University of Hawaii  
Institute for Astronomy

DWG # <b>T3-2092</b>	REV -	TITLE <b>Mirror Cooling Relay &amp; Temp Board</b>
ENGINEER E. Warmbier	LAST EDIT 12/14/2009 10:01:20 AM	SIZE <b>B</b>
FILE: Z:\Mirror Cooling\Protel Board Design\PG1.SchDoc		SHEET 1 of 2

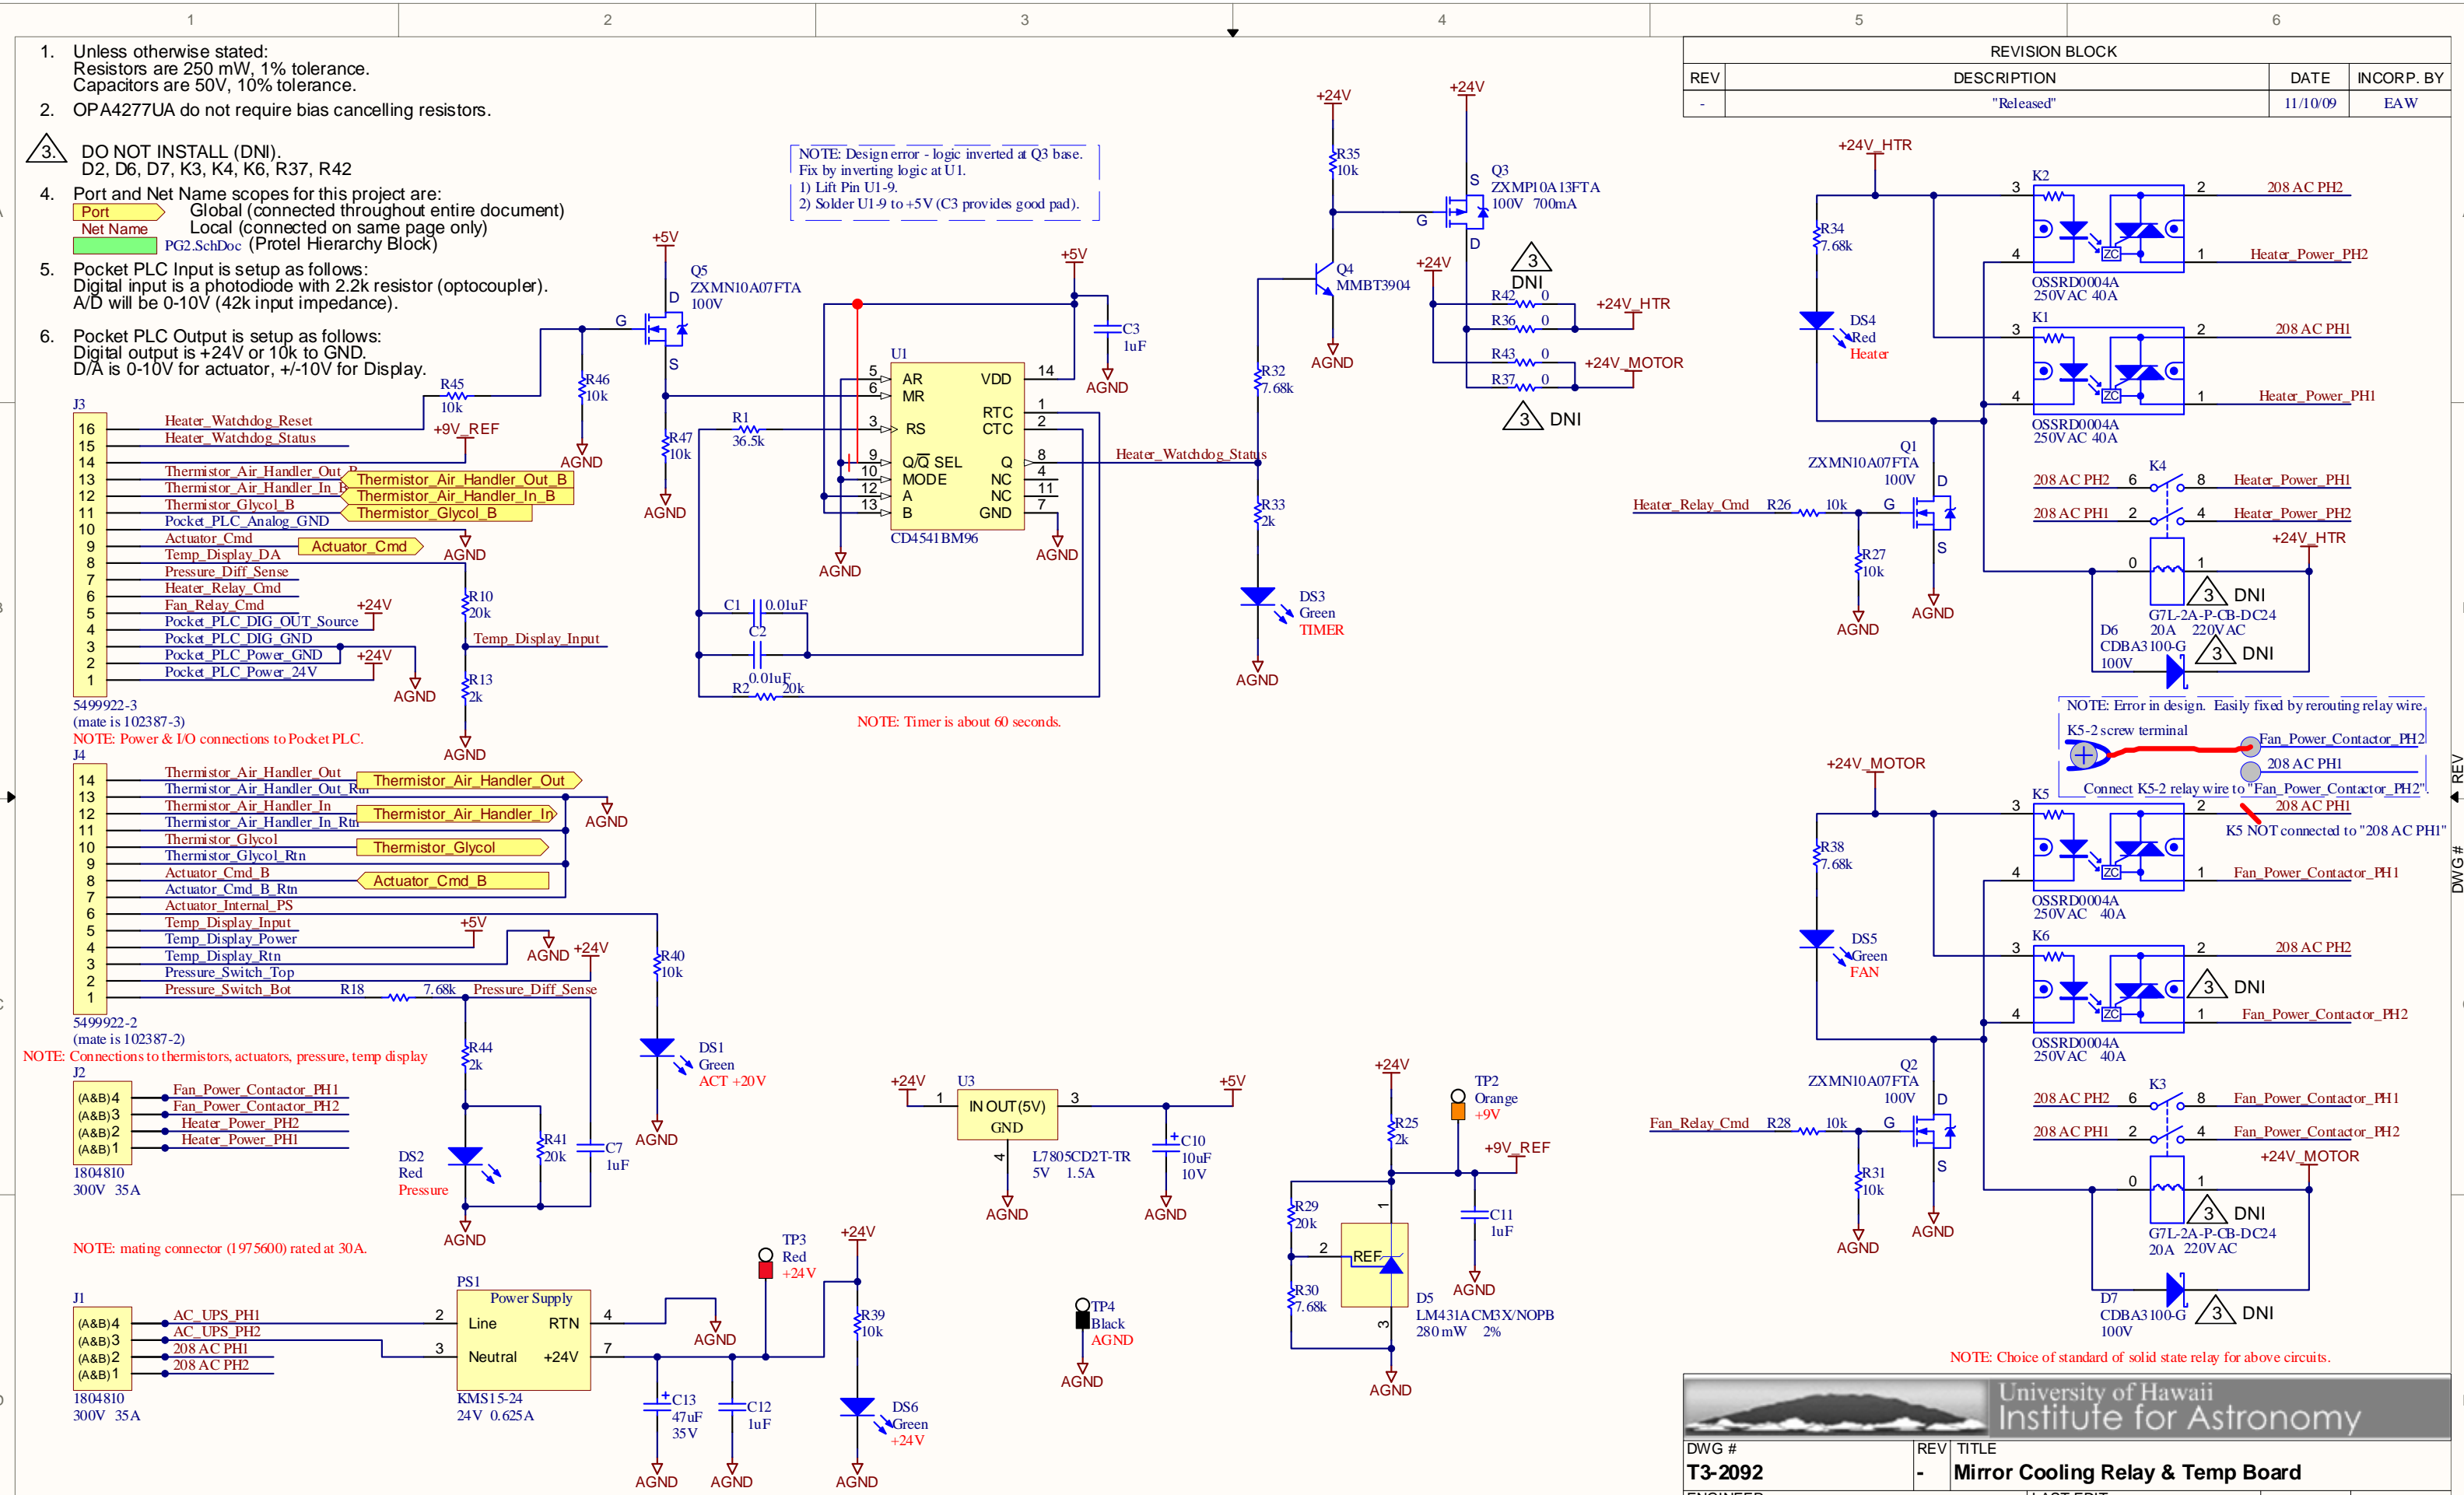
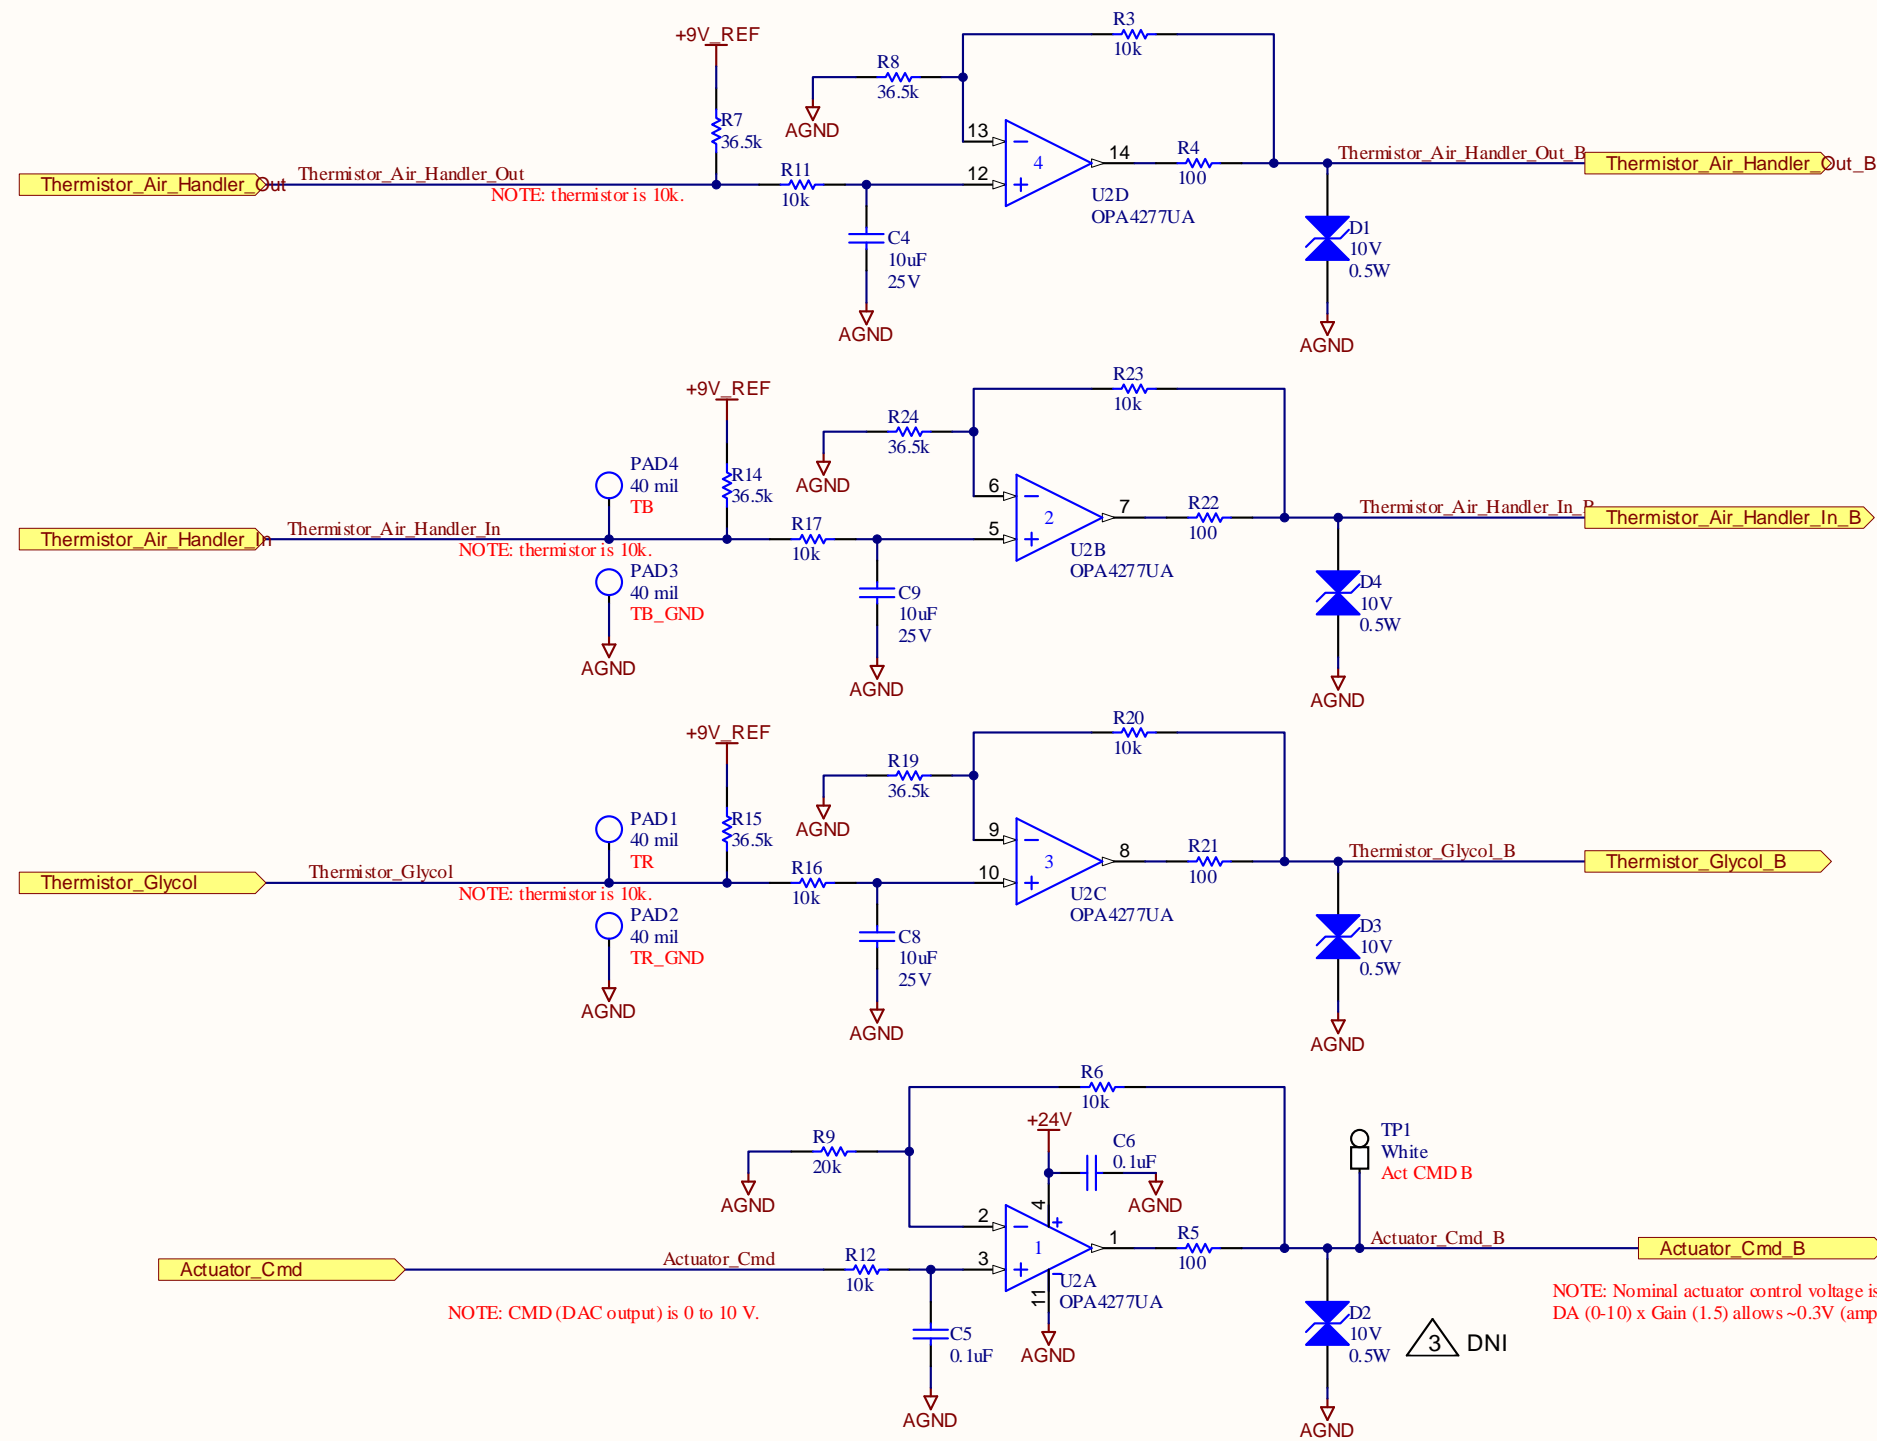
NOTE: Design error - logic inverted at Q3 base.  
Fix by inverting logic at U1.  
1) Lift Pin U1-9.  
2) Solder U1-9 to +5V (C3 provides good pad).

NOTE: Error in design. Easily fixed by rerouting relay wire.  
K5-2 screw terminal  
Connect K5-2 relay wire to "Fan\_Power\_Contactor\_PH2".  
K5 NOT connected to "208 AC PH1"
